REPORT AMENDED BY STAFF 4-13-89
CITY PLANNING COMMISSION

- APPLICATION:**
- A. Negative Declaration
 - B. Tentative map to establish two lots for air space condominium development.
 - C. Special Permit to develop 172 condominium units on 13+ vacant acres in the Single Family Alternative (R-1A) Zone.

PROPOSAL: The applicant is requesting the necessary entitlements to construct a 172 unit condominium project on 13+ vacant acres.

12
 44-33-89
 3-23-89
 FRANKLIN VILLAGE #2
 SACRAMENTO, CA
 PLANNING ITEM #
 ARCHITECTURE
 BUZZ GARCIA ASSOCIATES
 1808 J STREET
 SACRAMENTO, CA 95811
 916-441-1111
 1B
 P-88-360
 8888

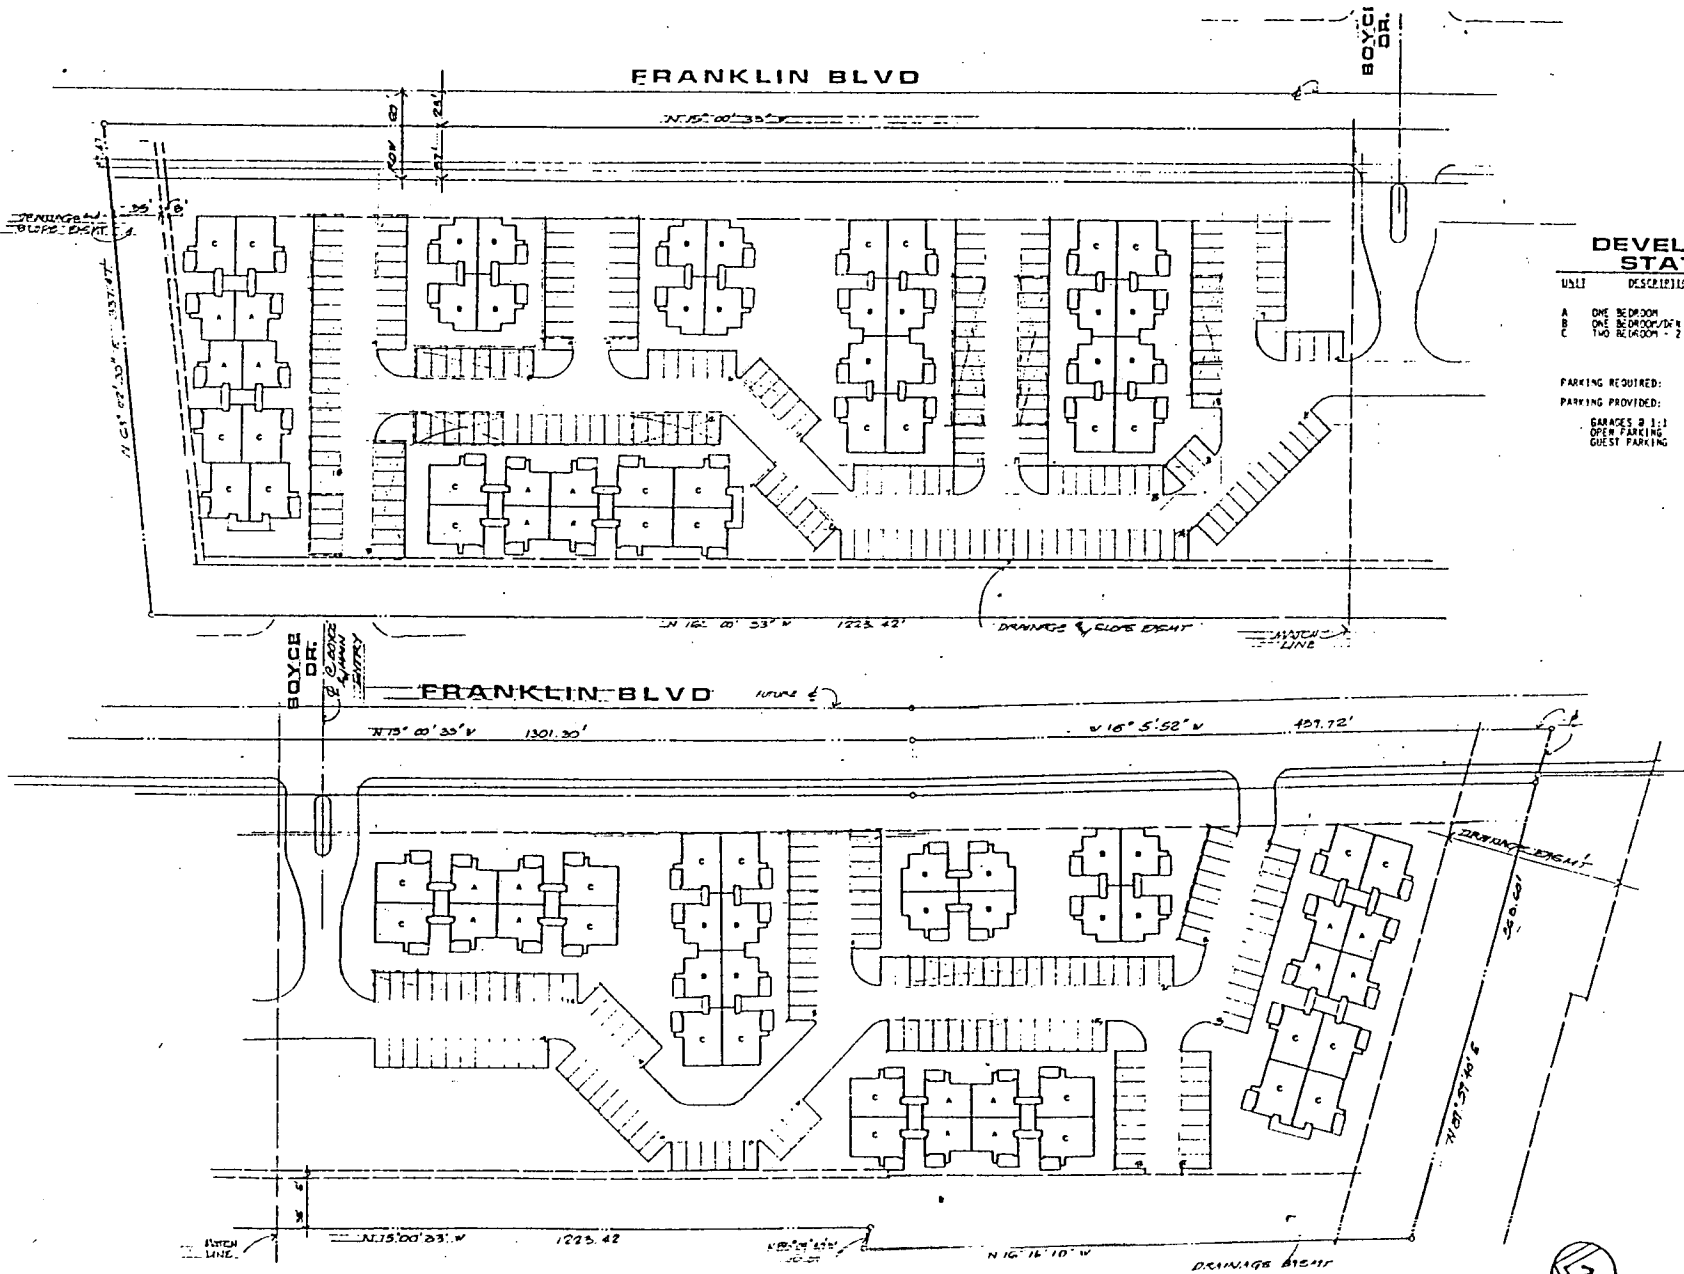
Staff is concerned over the disproportional share of parking without garages proposed for Lot 2. Due to the need to redesign the layout and placement of buildings, staff recommends that on each lot, the ratio of one garage per unit be provided and adequate outdoor parking provided per lot as per the Multiple Family Design Guidelines, Exhibit A.

The submitted site plan indicates a 25 foot building setback from the Franklin Boulevard right-of-way. Staff recommends that this area be increased to 30 feet and be landscaped with a variety of trees and shrubs and minimum five foot high berm with six foot high sound wall. Walkways crossing this landscaped area from Franklin Boulevard to the condominium units should be prohibited to prevent parking along Franklin Boulevard.

The site is surrounded on the remaining three sides by a drainage canal. Staff recommends that large evergreen trees should be planted adjacent to the north, south and west property lines in order to screen the canal from the condominium units. Should the levees require widening, landscaping is to be relocated. A swimming pool and pond were previously indicated but not shown on the site plan. The location of these facilities should be shown on the revised site plan subject to Planning Director review and approval.

Staff recommends that the applicant redesign the site plan to comply with the multiple family design guidelines for condominium projects. The revised drawings shall show the following items which were previously required.

END ELEVATION at 'C' UNIT

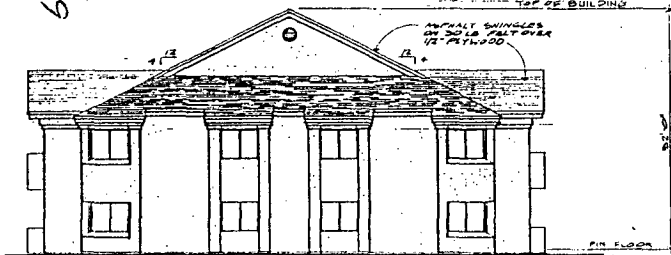
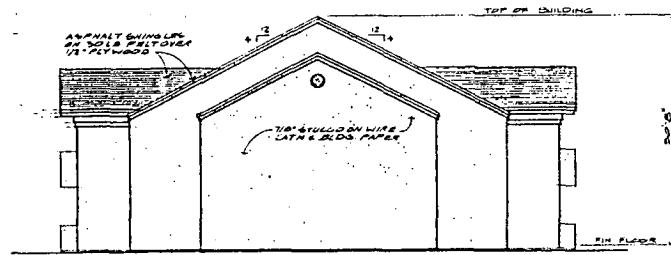
The applicant proposes to construct the condominium structures utilizing stucco with wood trim. Staff notes that the buildings are attractively designed and will be compatible with adjacent residential uses. Staff recommends that a wood shake roofing material be used, subject to Planning Director review and approval. The applicant should also be aware that the height limit in the Garden Apartment zone is 35 feet. The elevations should reflect this height requirement. The end elevations need to be redesigned with window elements.
